ADDENDUM NO. 1

Plans & Specifications for: Elsie Turner Field & Graverson Playground, Waltham, MA

In accordance with documents prepared by: Carolyn Cooney & Associates

2 CONCRETE MOW STRIP
 SCALE: 1" = 1'-0"

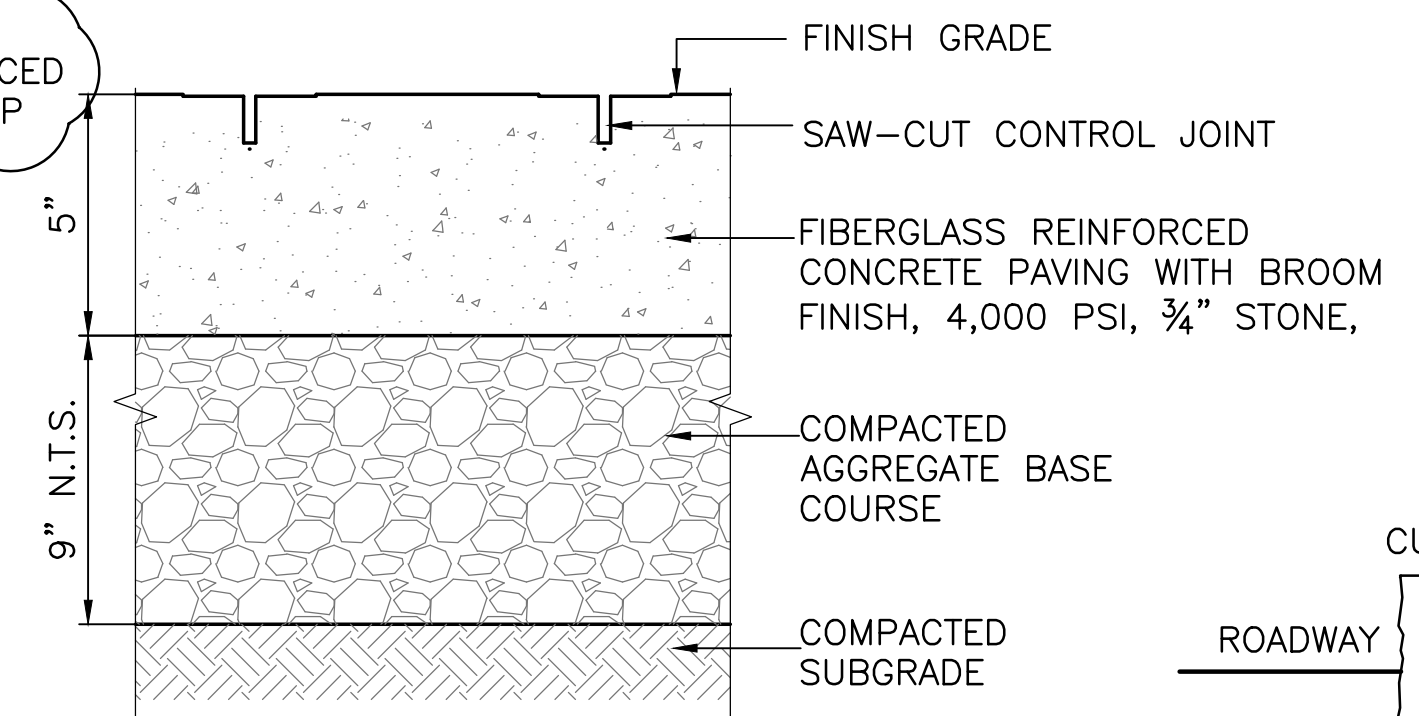
- ITEM NO. 18** *Elsie Turner Field: Replace Drawing L.602 with new Drawing L.602 attached. Revision is to dimensions of mow strip.*
- ITEM NO. 19** *Elsie Turner Field: Replace Drawing L.605 with new Drawing L.605 attached. Revision is to Chain Link fence mow strip.*

No.	Description	Date
△	NEW DWG ADDENDUM #1	11/20/17

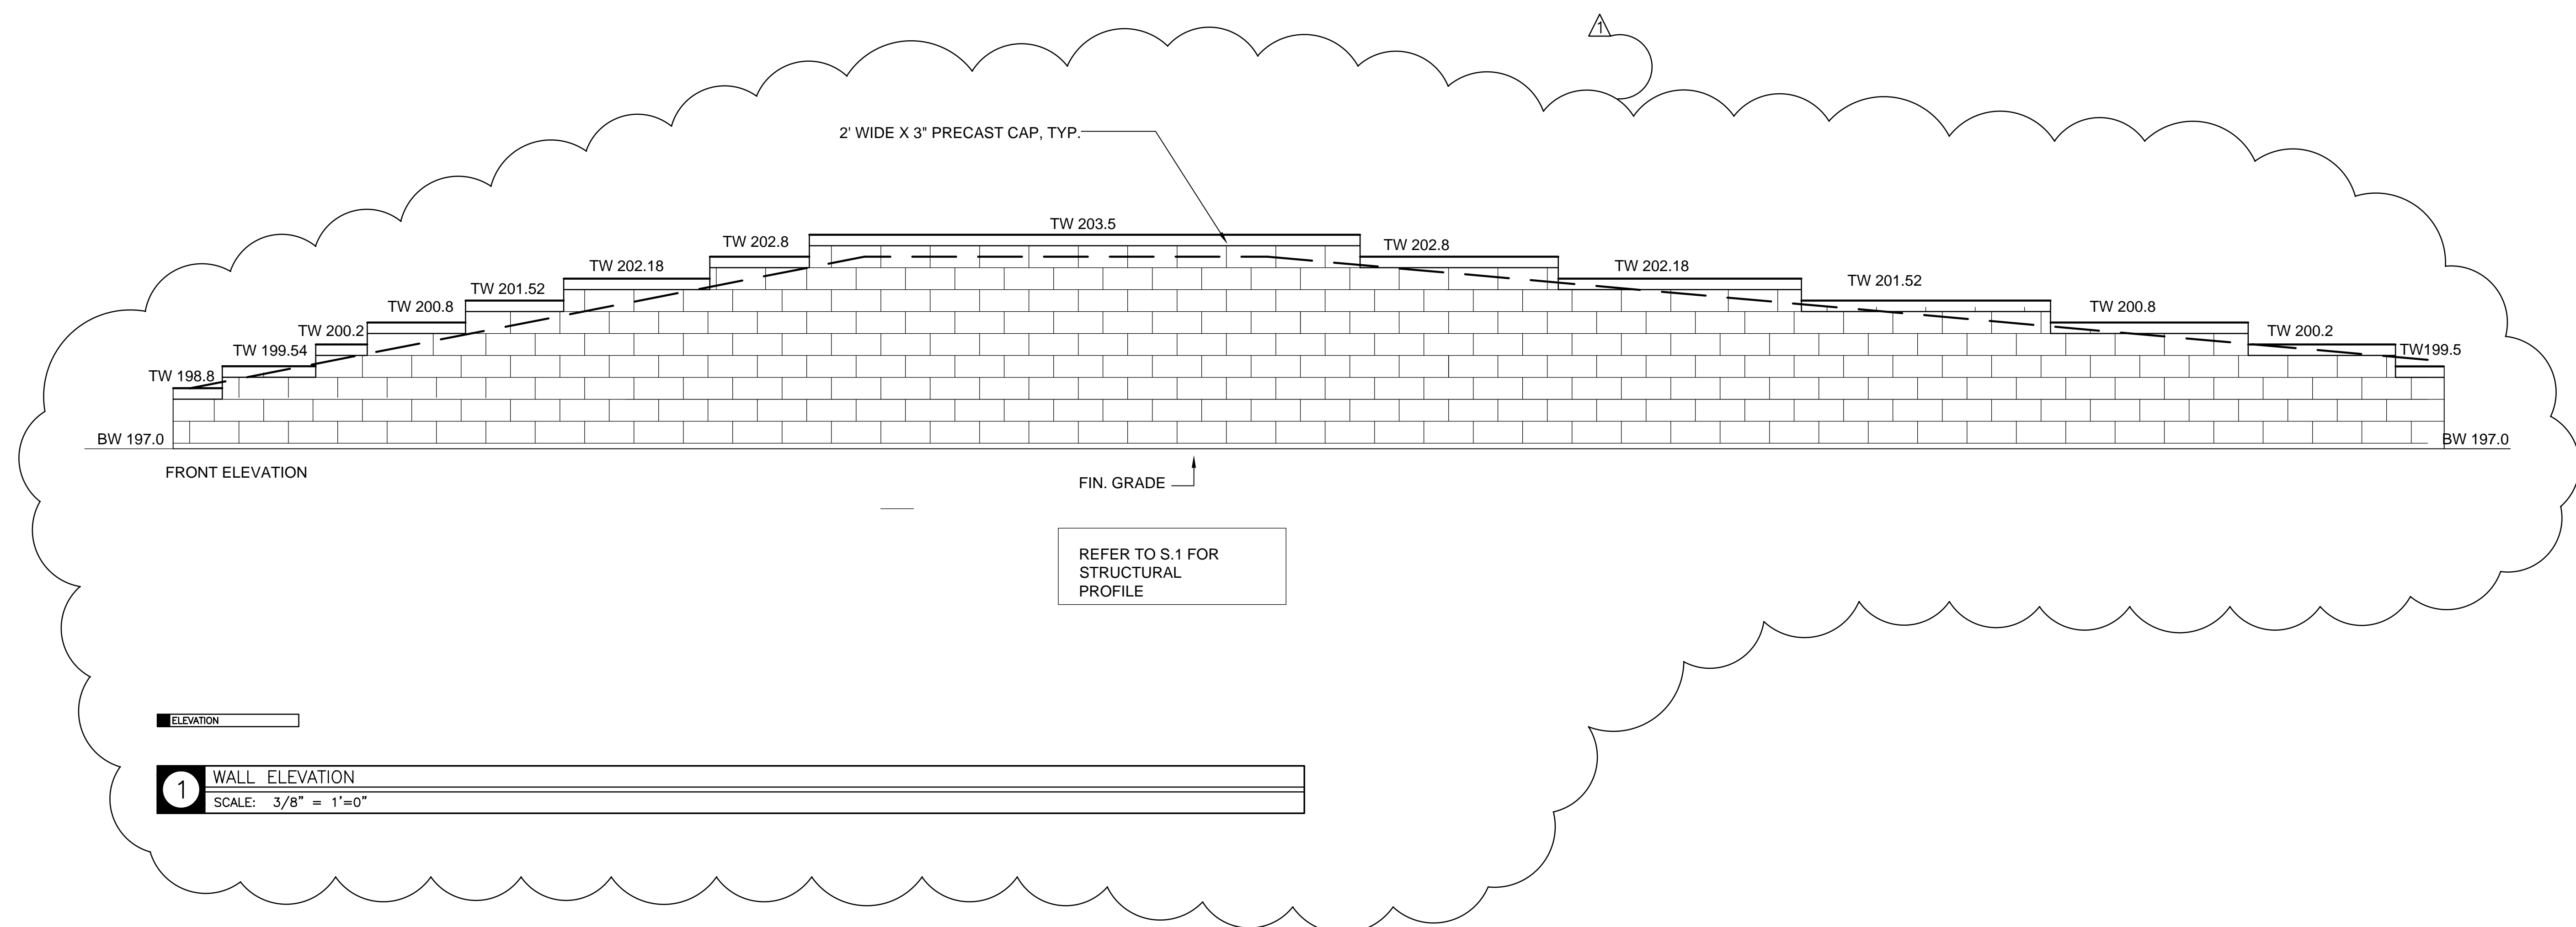
- ITEM NO. 20** *Elsie Turner Field: Replace Drawing L.606 with new Drawing L.606 attached. Revision is to mow strip at backstop.*
- ITEM NO. 21** *Elsie Turner Field: Add new drawing L.609 attached. Revision is to height of retaining wall.*

L.612

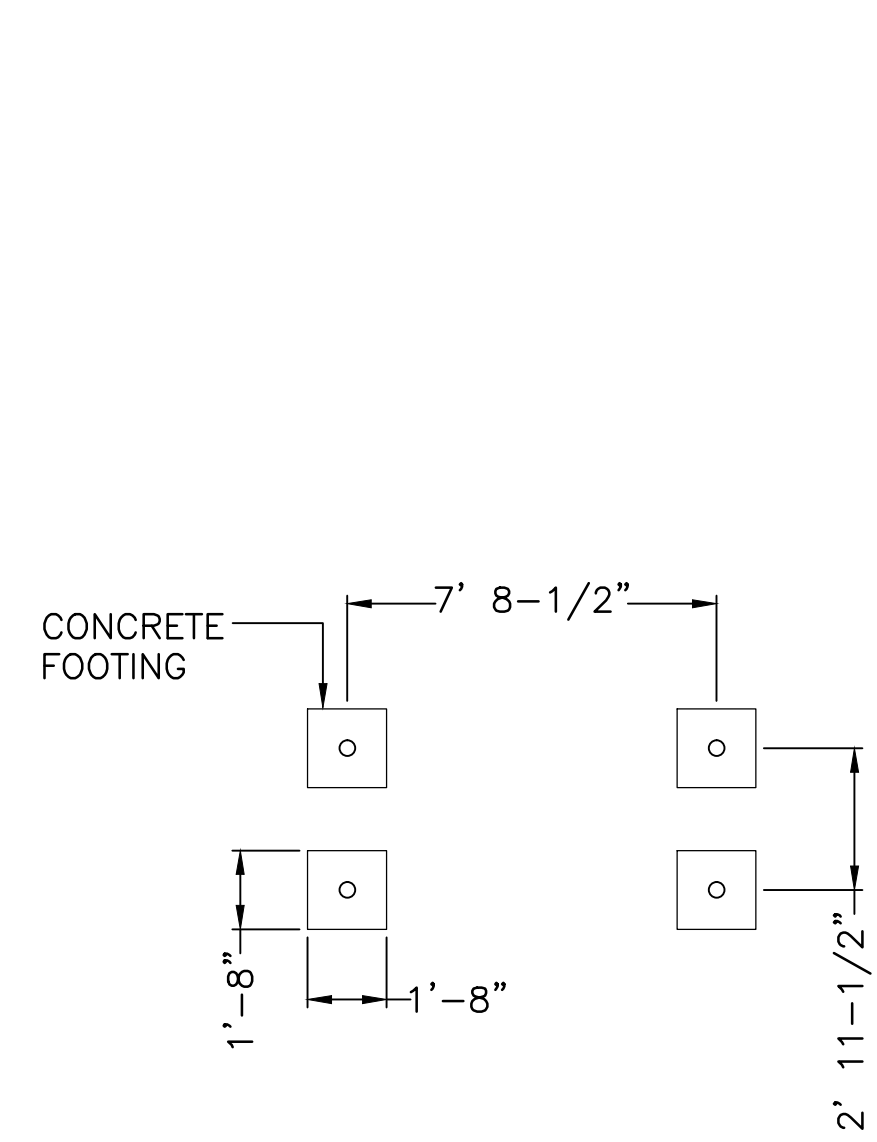
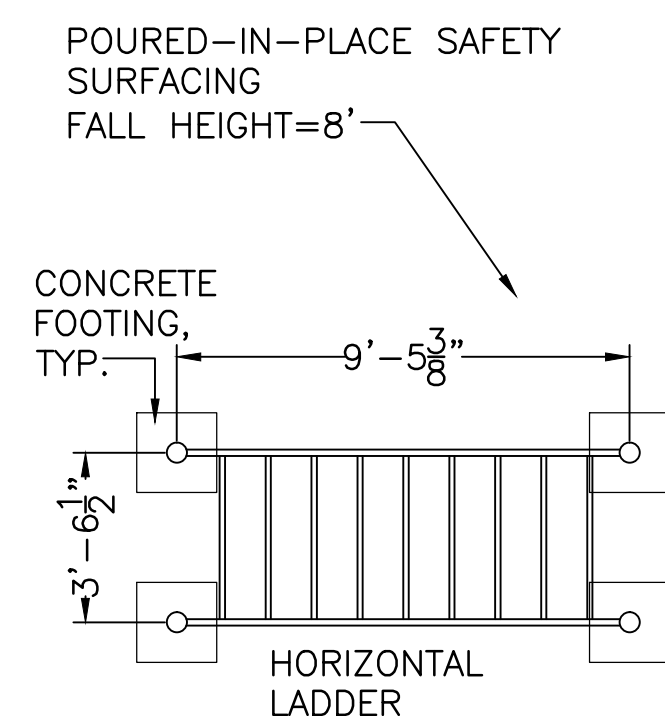
- ITEM NO. 22** *Elsie Turner Field: Replace Drawing L.612 with new Drawing L.612 attached. Revision is to exercise area equipment and layout.*
- ITEM NO. 23** *Elsie Turner Field: Replace Drawing L.613 with new Drawing L.613 attached. Revision is to delete Back Extension.*
